Subject: 2015 Annual Radioactive Effluent Release Report

BYRON NUCLEAR POWER STATION
ANNUAL RADIOLOGICAL EFFLUENT RELEASE REPORT (ARERR)
2015

Byron Station
ODCM Revision 11 Change Determination
CY-AA-170-3100

Byron Station
ODCM Revision 11 Change Summary Matrix

Figure 6.3a
Inner Ring and Special Interest Dosimeter Locations

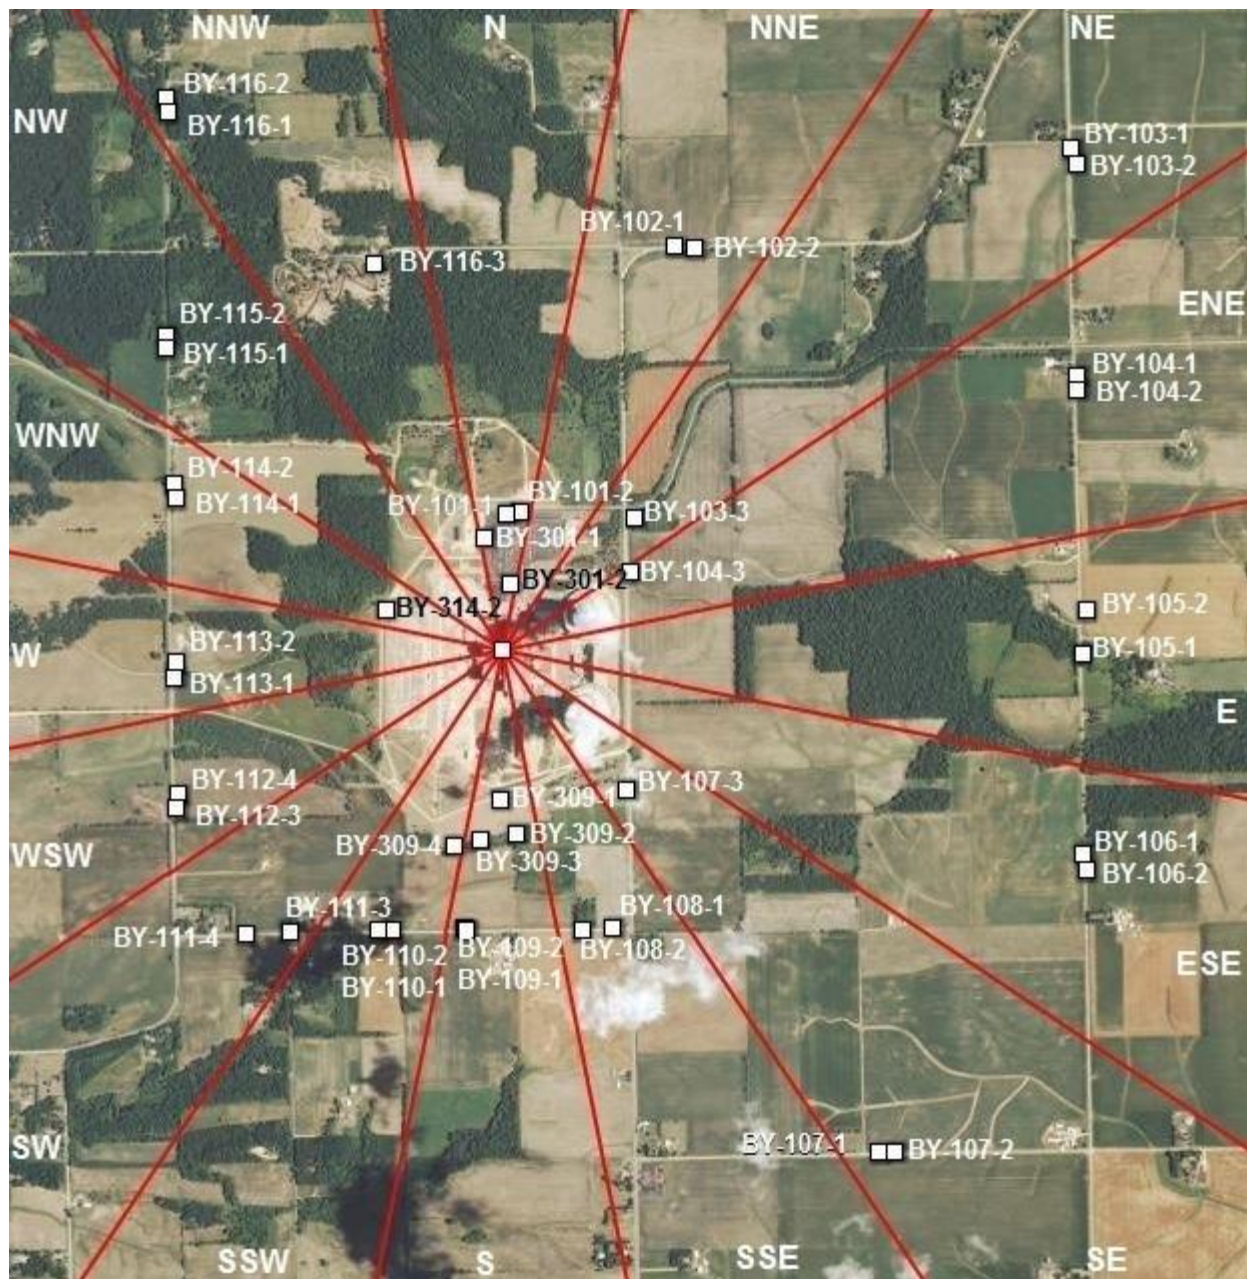
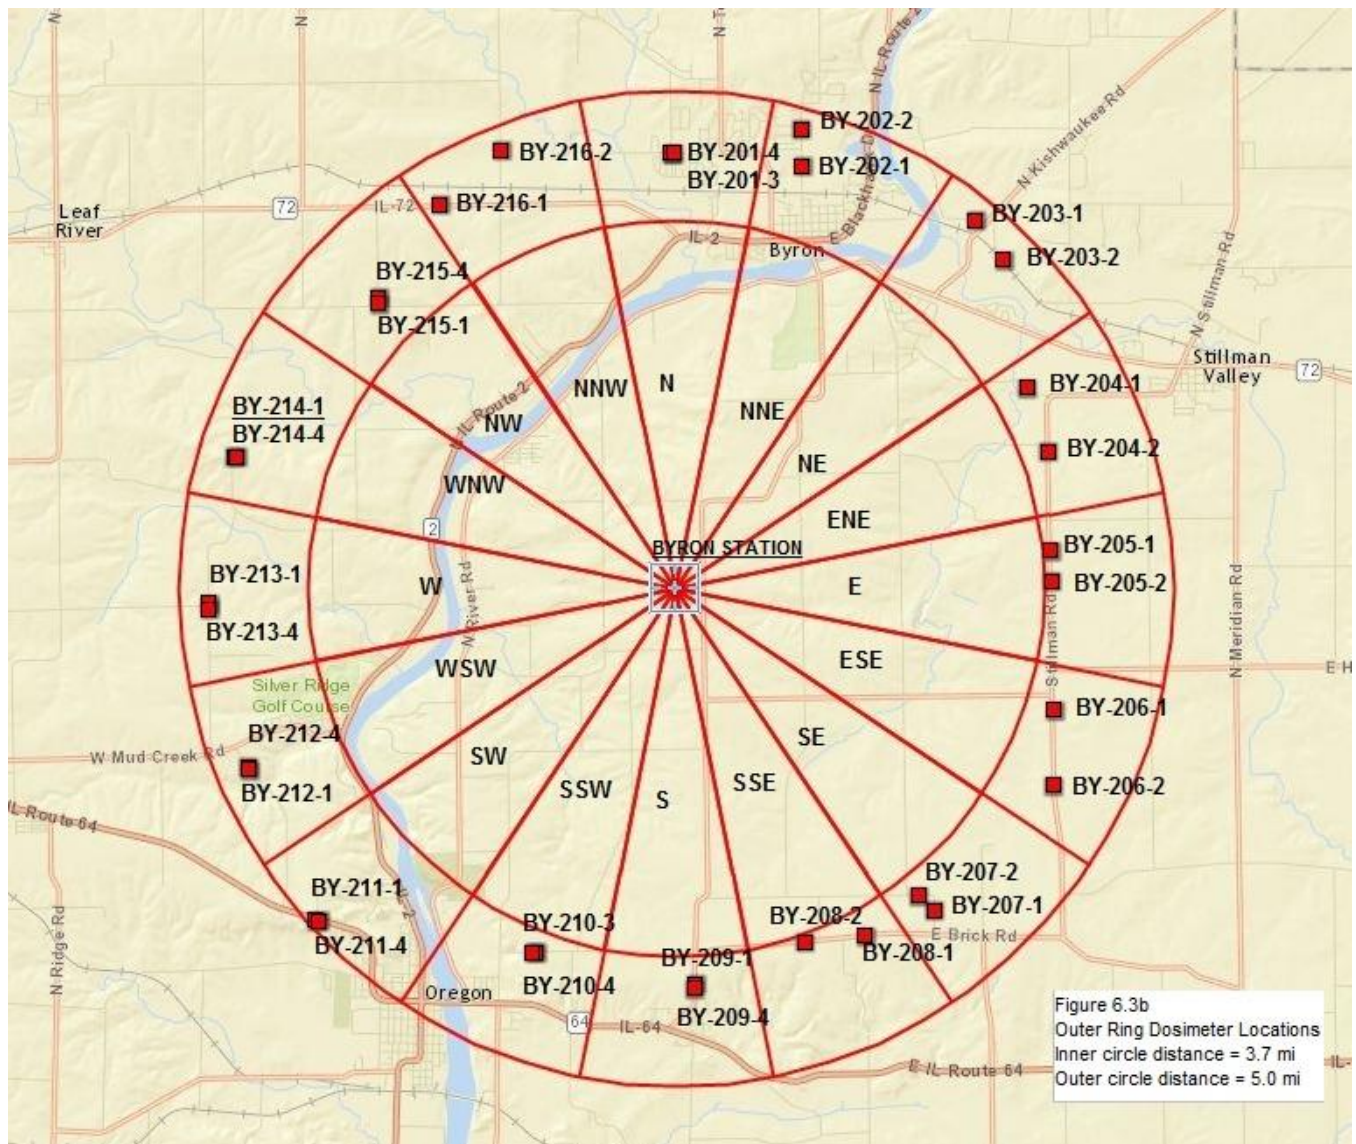
3.	Table of Contents Page 6 of 7	Page 5 of 188	D	Changed Figure 6-3, "Inner Ring & Outer Ring Dosimeter Locations" to Figure 6-3a, "Inner Ring & Special Interest Dosimeter Locations," page 181. Added Figure 6-3b, "Outer Ring Dosimeter Locations," page 182.

15.	Page II.6-13	Page 181-182 of 188	D	Made the following modifications to Figure 6-3, Inner Ring and Outer Ring Dosimeter Locations: <ul style="list-style-type: none"> Removed Figure 6-3 and created 2 new maps consisting of Figure 6-3a, Inner Ring and Special Interest Dosimeter Locations, and Figure 6-3b, Outer Ring Dosimeter Locations Added the Special Interest Dosimeters to Figure 6-3a, which were not previously mapped on Figure 6-3 Changed the meteorological sector designator labels from A through R to compass direction labels (N, NNE, NE, etc.) Changed the circle distance rings from 2 and 5 miles (generated from EP zone maps) in Figure 6-3, to 3.7

and 5.0 miles (TRM Table T3.12.a-1 Section 2 requirements) in Figure 6-3b.
16.	Page II.6-17	Page 181-186 of 188	A	Corrected typo for BY-115-1 dosimeter longitude location from -89.27905 to -89.29705
17.	Page II.6-18	Page 181-187 of 188	A	Corrected typo for BY-201-4 dosimeter latitude location from 42.01381 to 42.13810
18.	Page II.6-19	Page 181-188 of 188	E	<p>Removed dosimeter location BY-302-1 and BY-314-1 and added dosimeters BY-301-2 and BY-314-2 with the following characteristics:</p> <p>BY-301-2: Lat 42.07685, Long -89.28230, Distance (km) 0.24, Distance (mi) 0.15, Direction (deg) 7, Sector A, Sector N</p> <p>BY-314-2: Lat 42.07601, Long -89.28764, Distance (km) 0.43, Distance (mi) 0.27, Direction (deg) 289, Sector P, Sector WNW</p>
